HIGHWAY WORK PROPOSAL

<u>COUNTY</u>	<u>STATE PROJECT</u>	<u>FEDERAL</u>	<u>PROJECT DESCRIPTION</u>	<u>HIGHWAY</u>
Sheboygan	1440-13-72	N/A	Fond Du Lac - Plymouth; WCL - CTH P	STH 023

Addendum No. 03
ID 1440-13-72
Revised Sheet 5
January 10, 2020

Addendum No. 03
 ID 1440-13-72
 Revised Sheet 584
 January 10, 2020

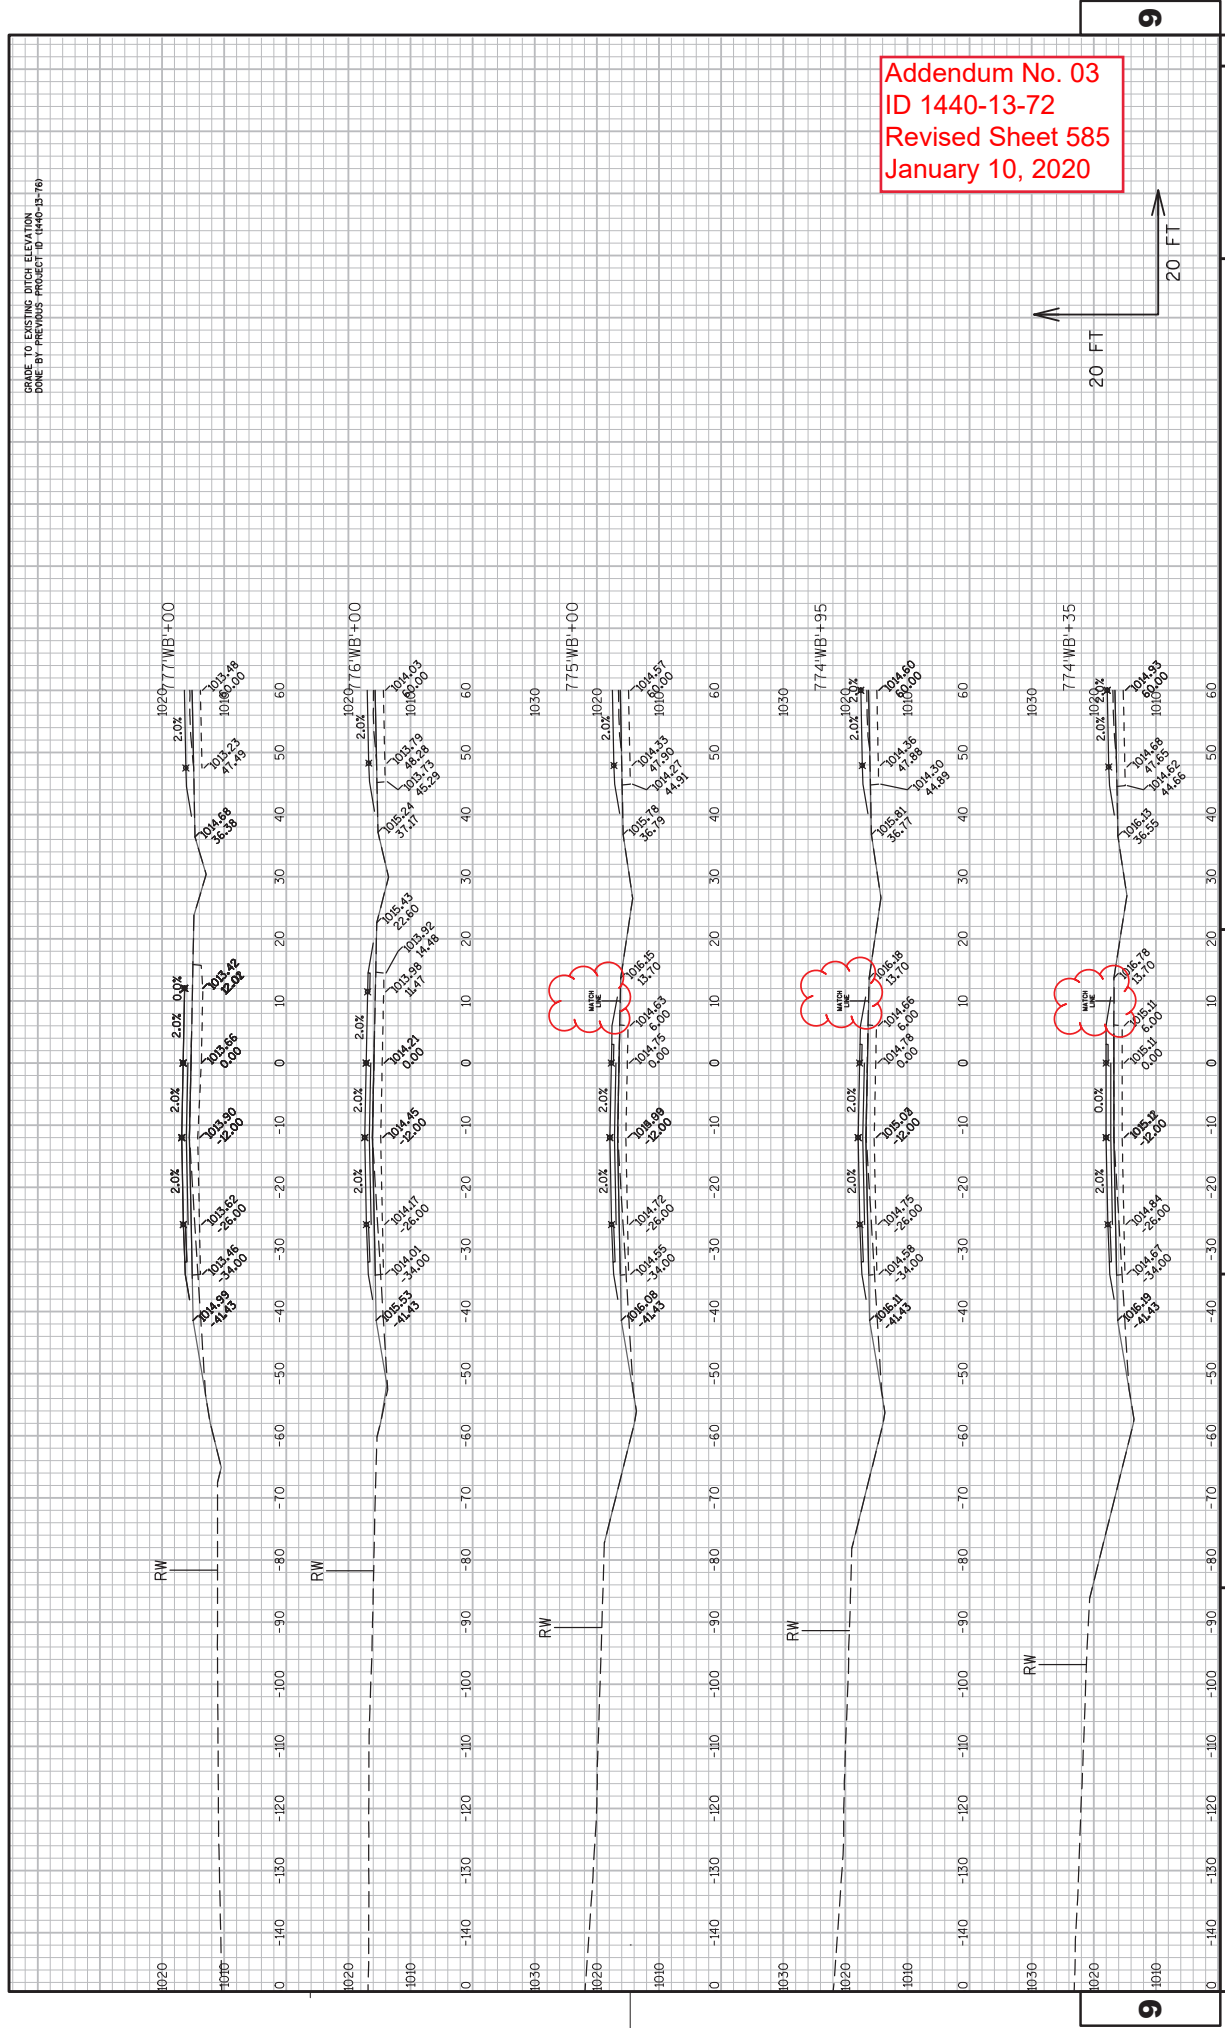
GRADE TO EXISTING DITCH ELEVATION
DONE BY PREVIOUS PROJECT ID (1440-13-72)
